New Albany Architectural Review Board Agenda
Monday, October 11, 2021 7:00pm

ARB-99-2021 Certificate of Appropriateness and Waivers

Certificate of Appropriateness for the development of a new church located at 5526 Dublin Granville Road and 5321 Harlem Road. Waivers have been requested to the landscaping requirements for the site and to New Albany Design Guidelines and Requirements Section 8 (Civic & Institutional Buildings) III(3) to not require a building entrance along the Dublin Granville Road building elevation (PID: 222-003431 and 222-002058).

LOCATION: 5526 Dublin Granville Road and 5321 Harlem Road (PIDs: 222-003431 and 222-002058)
APPLICANT: M+A Architects c/o Jeff Hefner
REQUEST: Certificate of Appropriateness & Waivers
ZONING: Agricultural (AG)
STRATEGIC PLAN: Residential
APPLICATION: ARB-99-2021

Landscape Plan
SCALE: 1" = 40'-0"

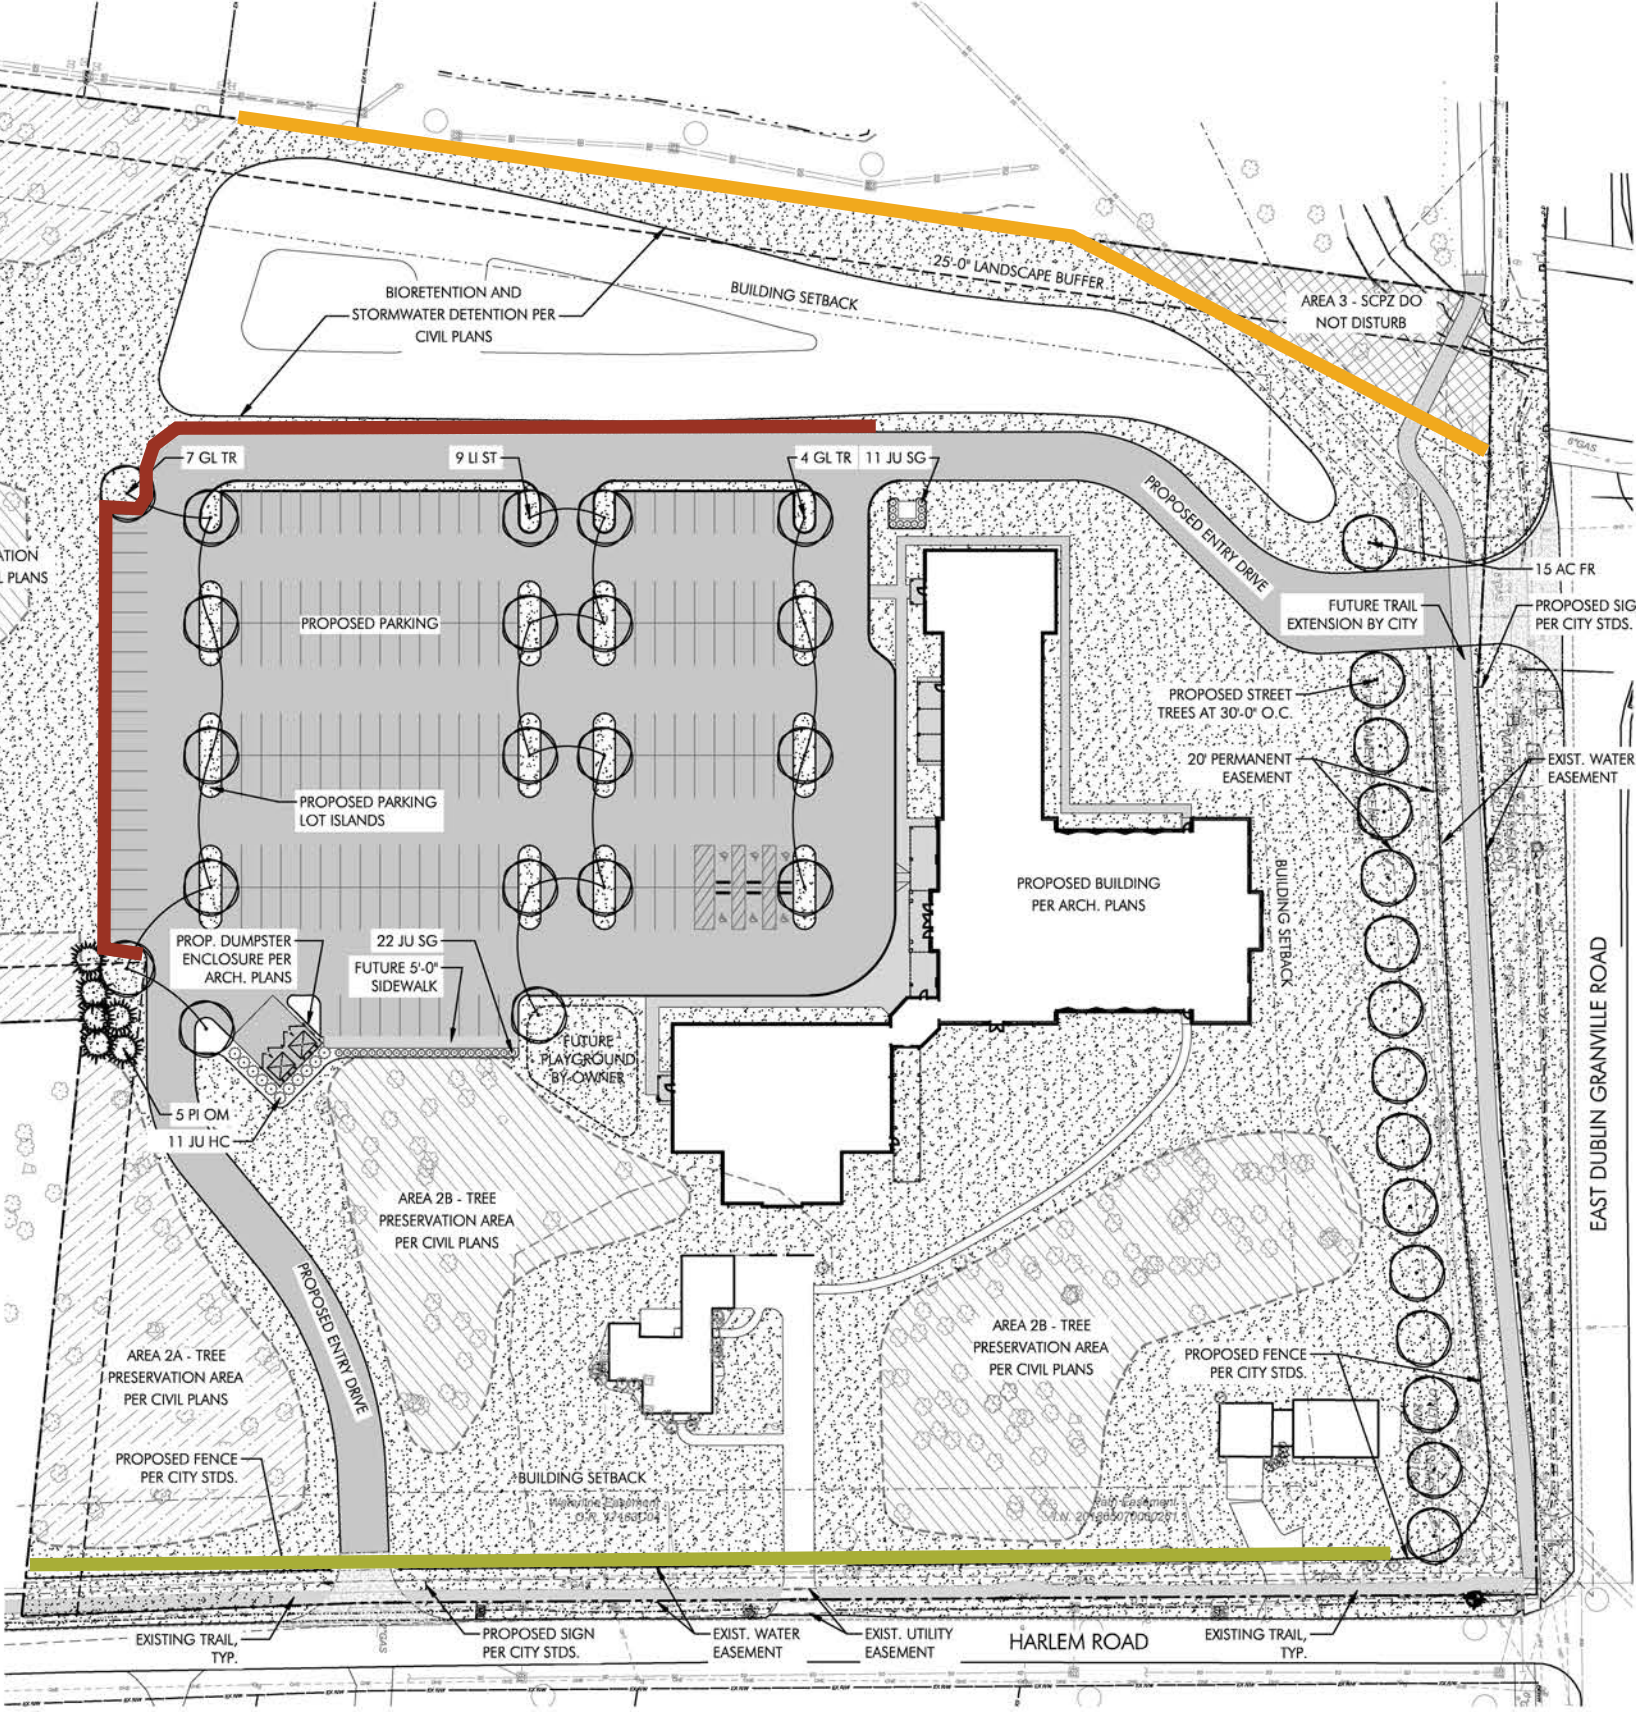
- Per C.O. 1171.06(b), parking lots must be screened from primary streets, residential areas and open space by a 3.5 foot minimum evergreen hedge, masonry wall or a combination of wall and plantings. Please refer to exhibit A which demonstrates where on the site this requirement is not being met. The applicant has requested a waiver from this requirement along the southern and western parking lot areas which will be evaluated under the waiver section of the staff report.
 - The applicant is partially meeting this requirement along the eastern boundary of the parking lot. The landscape plan indicates that 24 inch parking lot hedgerow will be installed in front of the parking spaces that face Harlem Road.
 - The site plan shows a future playground area between the proposed hedgerow and building resulting in a gap in the headlight screening. staff recommends a condition of

approval that additional hedgerow screening be added around the “future playground” space indicated on the plans to fully meet this requirement since it is adjacent to the parking area.

- Per C.O. 1171.04(a), street trees along Harlem and Dublin Granville are required to be planted at an average rate of one tree for every 30 feet of linear lot frontage.

- Dublin Granville Road: $590 \text{ feet of frontage} / 30 = 20$ required street trees. The applicant proposes to install 15 street trees and the requirement is not met. Staff recommends that an additional 5 street trees be planted along Dublin Granville Road and that all street trees planting be randomized (staggered and installed on both sides of the leisure trail) in order to be more in character with the rural area.

1. Street trees along Dublin Granville Rd should be planted in random massings of native deciduous shade trees. Include more variety of species and provide the required quantity of trees.

2. Street trees along Harlem Rd should be planted in random massings of native deciduous shade trees.
 3. Provide planting in basin in order to meet 75% screening opacity in 5 years from installation. Trees should be planted with naturalized spacing and grouping.

1. The future playground and patio improvements are subject to staff approval and must be screened from adjacent properties, subject to staff approval.
2. Parking lot hedgerow screening be added around the "future playground" space indicated on the plans to fully meet the parking lot headlight requirement, subject to staff approval.
3. The minimum 3.5-foot minimum evergreen hedge for headlight screening and the 75% opacity screening is provided along the western side of the property where the detention basin is located, subject to staff approval.

4. Additional landscape must be planted on the site if the minimum 75% opacity screening is not achieved with existing landscaping at any location on the site, subject to staff approval.
5. 5 additional street trees be planted along Dublin Granville Road and that all street trees planting be randomized (staggered and installed on both sides of the leisure trail) in order to be more in character with the rural area, subject to staff approval.
6. The city landscape architect comments must be addressed, subject to staff approval.
7. The drive aisle that extends from Harlem Road must be reduced from 24 feet to 22 feet.
8. Future, exterior repairs to the existing home site are subject to staff approval.
9. Street trees are added along Harlem Road and their location are subject to staff approval.

architectural site plan
40' 20' 10'

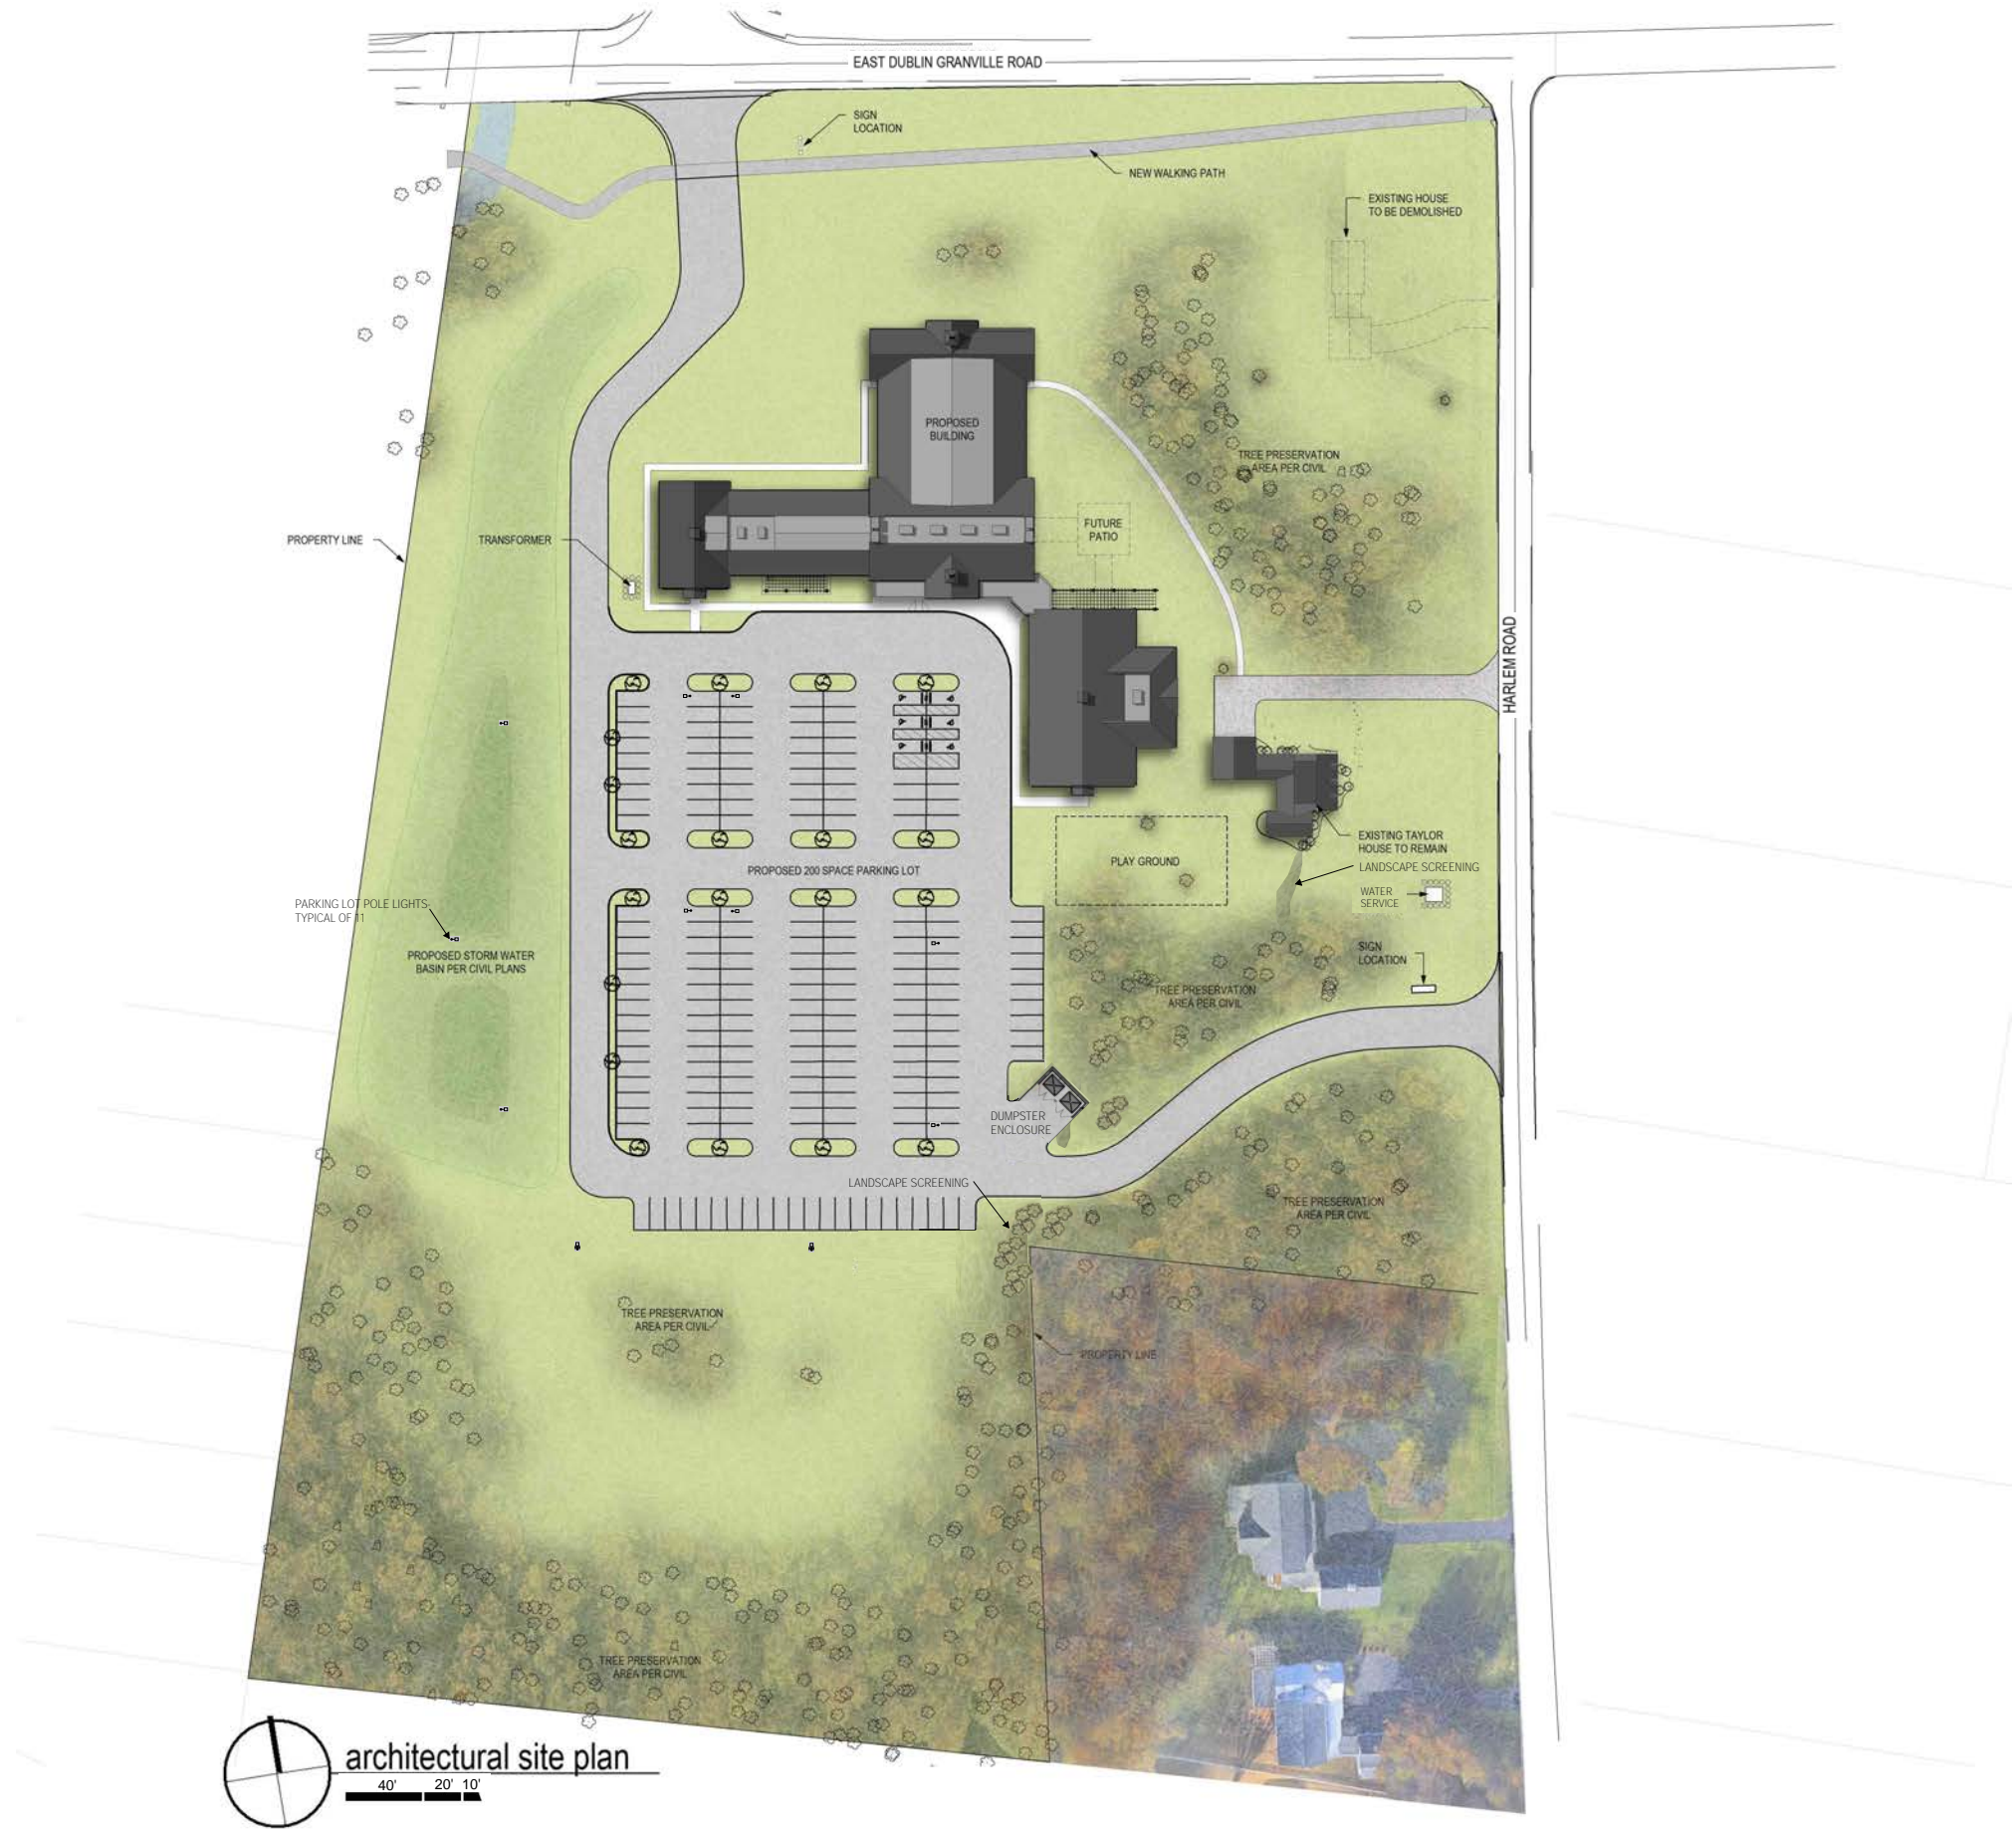
1. C.O. section 1171.06(b) requires a 3.5' hedge or screen for parking lots that are adjacent to primary streets and residential areas. We will meet this requirement on the east and southeast corners of the parking lot. However, we request a waiver for the south edge of the parking lot. The intent of the screening is primarily for headlight shielding and visual screening of parked cars from residential properties. Please reference the Civil Site Plan C-102 AND Exhibit D Tree Clearing Plan. At the south condition of our site, we have maintained an existing 80' deep tree line and have not removed the underbrush creating a screen between the properties. The grade of the south property line is itself 4 feet to 2.5 feet above the parking surface creating its own screen. The edge of the property is also 300' away from the parking lot. The combination of an 80' buffer of trees filled underbrush and the rise in grade would satisfy the intent of the code.

2. We also request a variance for parking lot screening for the west side of the lot as this boundary is adjacent to the City of Columbus and the majority of that area is a retention basin in the City of Columbus. Please reference the Civil Site Plan C-102. Since it is a retention pond and it is in the city of Columbus, please consider that the code intent of screening the view of parked cars and headlights for a retention basin should not apply to this condition.

4. C.O. 1171.04(a) requires street trees, 1 every 30', along Dublin- Granville Road and Harlem Road. We will provide street trees per code for Dublin-Granville
